Service Bulletin

No. : MZ04-003

Model: SR7400

Subject: Sound cuts out (short-time) during Dolby Digital and DTS decoding.

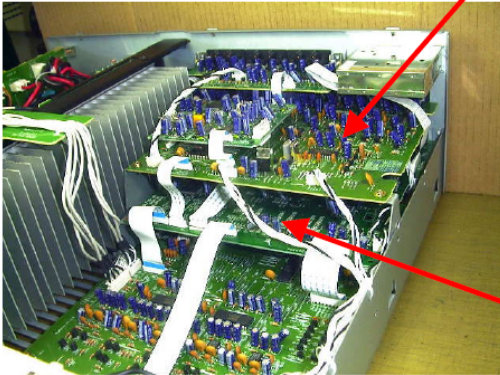
Symptom: 1) When Dolby Digital and DTS decoding, the sound cuts for about 0.5-second. This occurs at random. It doesn't occur in PCM decoding.
2) It occurs when Dolby Digital and DTS are decoded with AUTO MODE.
3) Occurrence timing varies. This phenomenon may occur in a very short time, or it may not occur even if 30 minutes or more passes.

Solution: Remove Capacitor C281 (33pF) located on DSP PCB.

C281

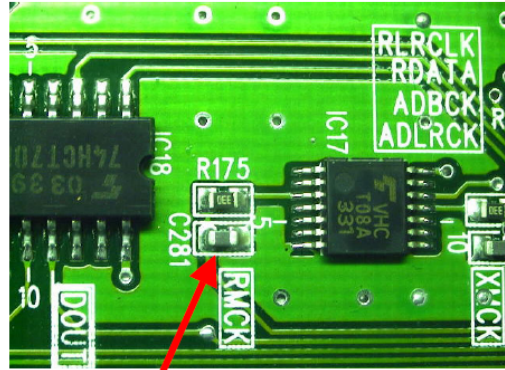
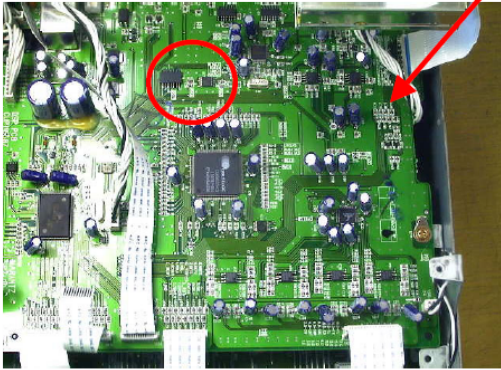
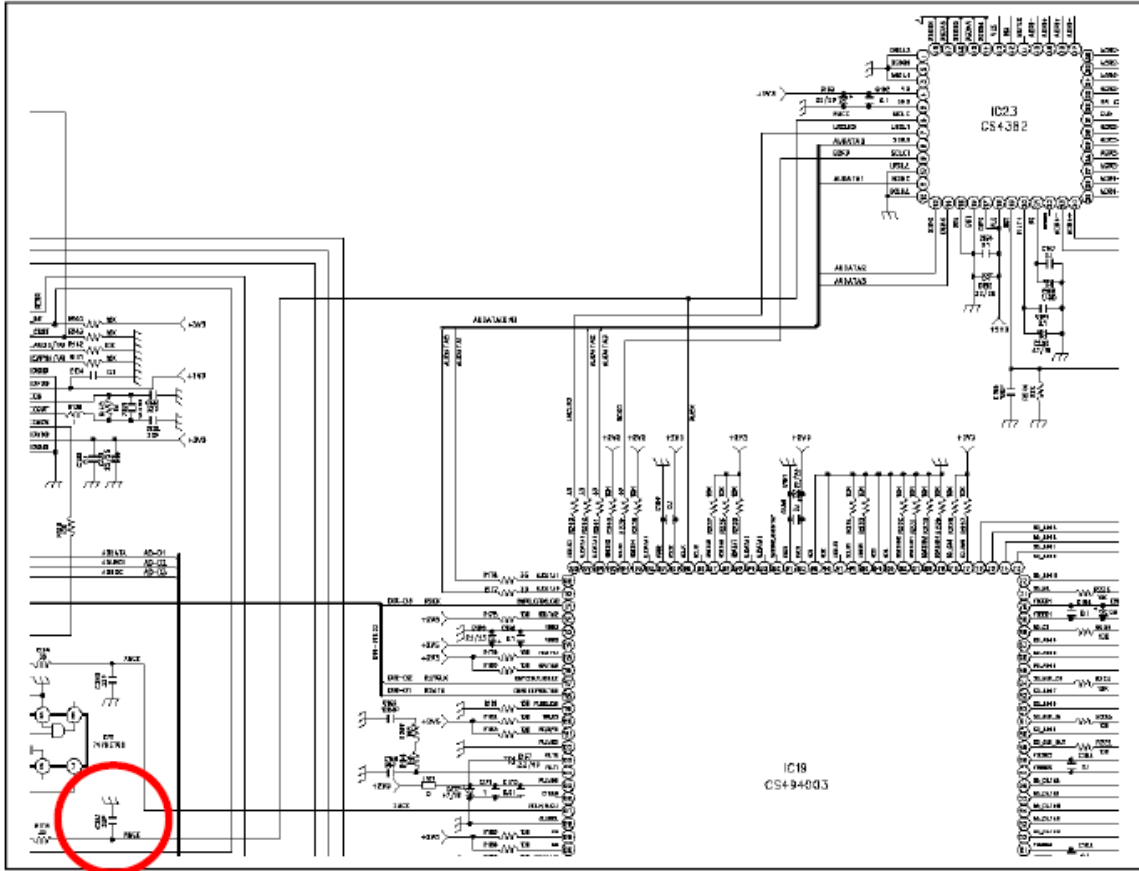
C281 REMOVAL PROCEDURE

- 1) Remove 9 screws of VIDEO PCB from REAR PANEL.
- 2) Remove 2 screws from VIDEO PCB.
- 3) Disconnect the connector and Flexible Flat Cable from VIDEO PCB.
- 4) You can remove VIDEO PCB, then you can see C281.
- 5) Remove C281.
